# NESC 2017 Changes Subcommittee 4 Clearances

NESC Workshop  
San Antonio  
October 11, 2016

# **Sub-Committee 4**

Rule 215C4a  
2012 Code

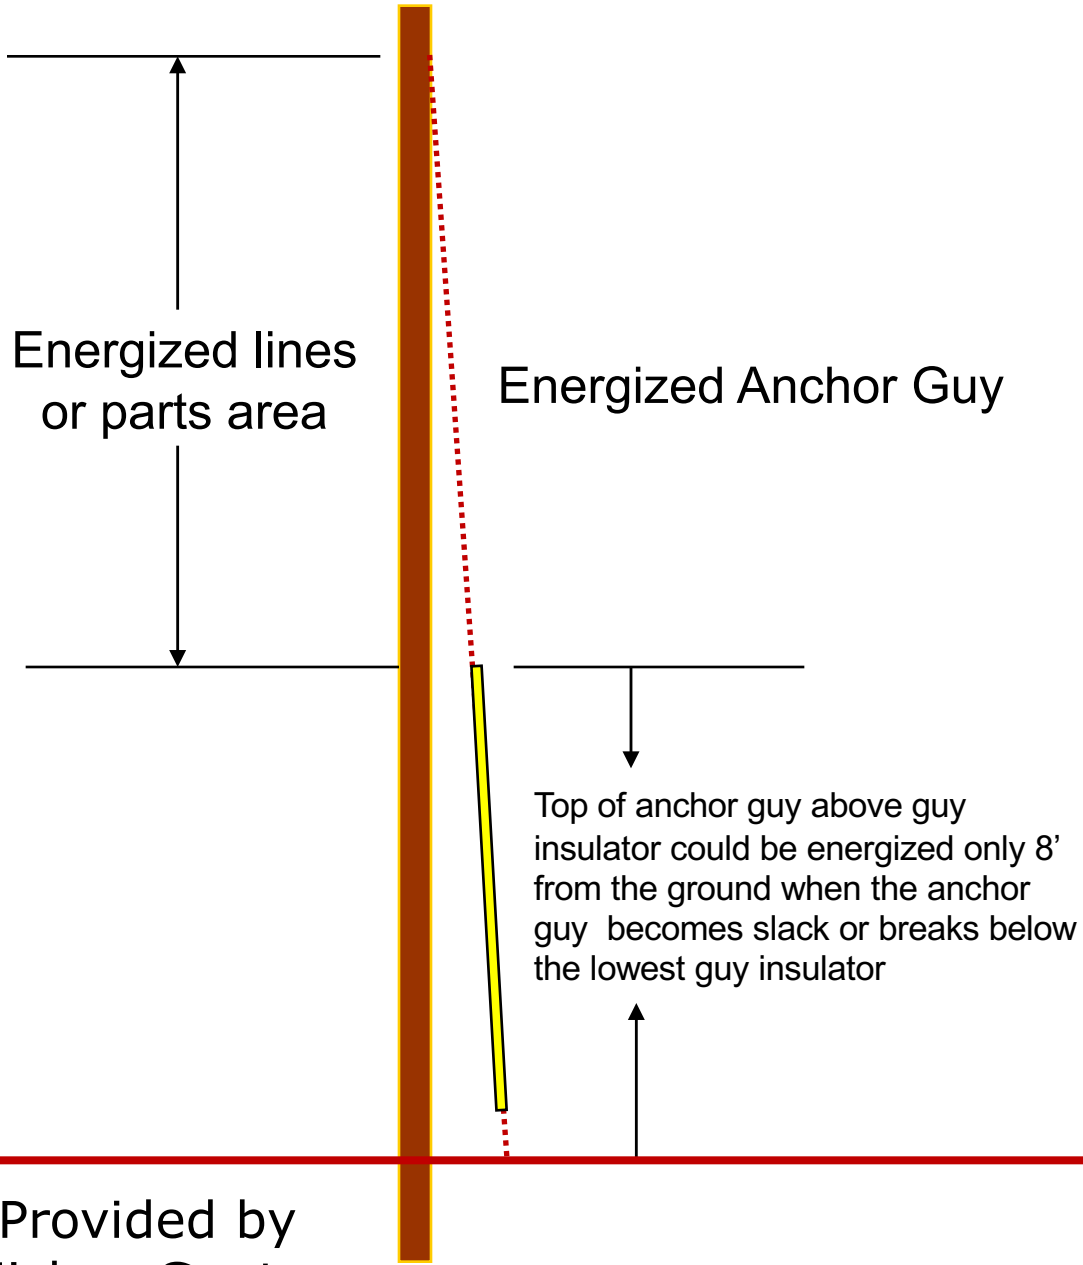
# Change Proposal 4701 Accepted as Modified Guy Insulators

- Rule 215C2a for 2017 NESC Requires Anchor Guys to be Effectively Grounded
  - Not a new Code requirement
  - The installation of guy insulators is an exception to the grounding rule
- Exception 2 to Rule 215C2a:
  - Guy insulators shall be positioned so as to limit the likelihood of any portion of an anchor guy becoming energized within 2.45 m (8 ft) of the ground level in the event that the anchor guy becomes slack or breaks.

- Redefined How To Consider Clearances if Guy Wire Were to Break

....in the event that the anchor guy becomes slack or *breaks below the lowest guy insulator.*

in the event that the anchor guy becomes slack or *breaks.*
